## *City of El Paso – City Plan Commission Staff Report*

**Case No:** SUSU13-00063 – Hill Terrace Addition Replat No. 1  
**Application Type:** Resubdivision Combination  
**CPC Hearing Date:** August 22, 2013  
**Staff Planner:** Nelson Ortiz, (915) 541-4931, [ortiznx@elpasotexas.gov](mailto:ortiznx@elpasotexas.gov)  
**Location:** East of US54 and North of Mobile  
**Acreage:** 8.015 acres  
**Rep District:** 2  
**Existing Use:** Vacant  
**Existing Zoning:** R-4 (Residential)  
**Proposed Zoning:** R-4 (Residential)  
**Nearest Park:** Park proposed within subdivision  
**Nearest School:** Coldwell Elementary School (0.44 mile)  
**Park Fees Required:** N/A  
**Impact Fee Area:** N/A  
**Property Owner:** City of El Paso  
**Applicant:** City of El Paso  
**Representative:** Brock & Bustillos

# HILL TERRACE ADDITION REPLAT NO. 1

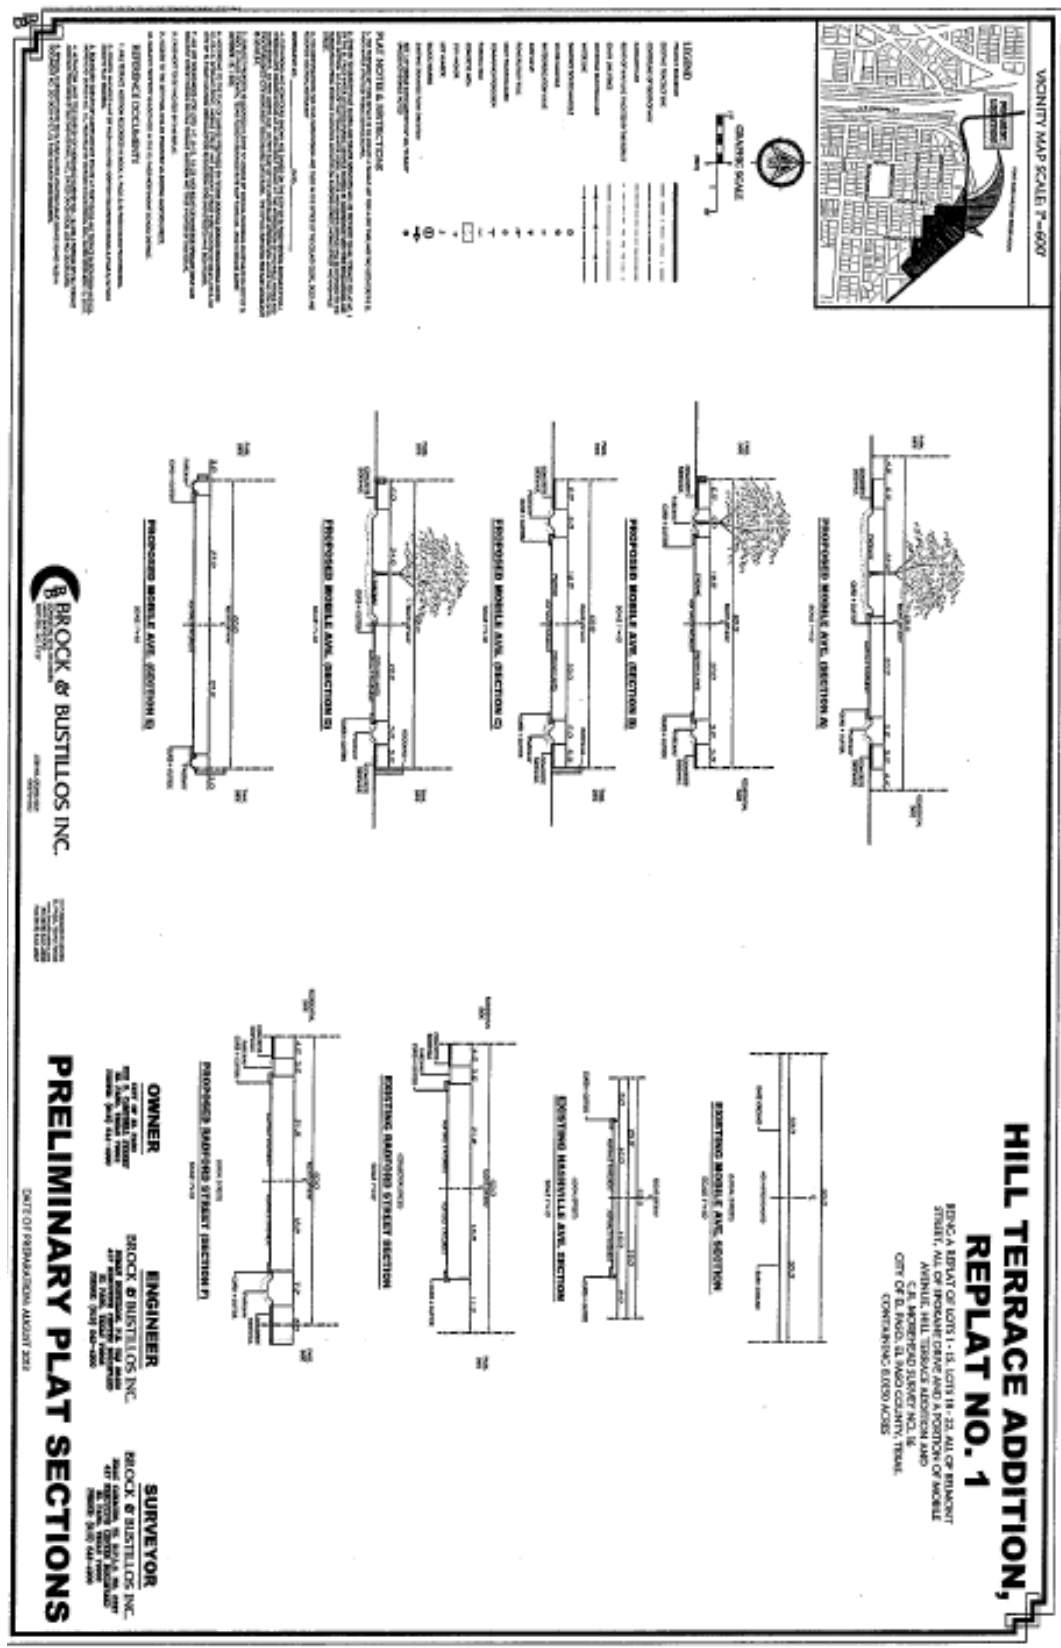
1. Include proposed drainage flow arrows on preliminary plat.
2. All developed storm water runoff shall be retained within the subdivision boundaries.
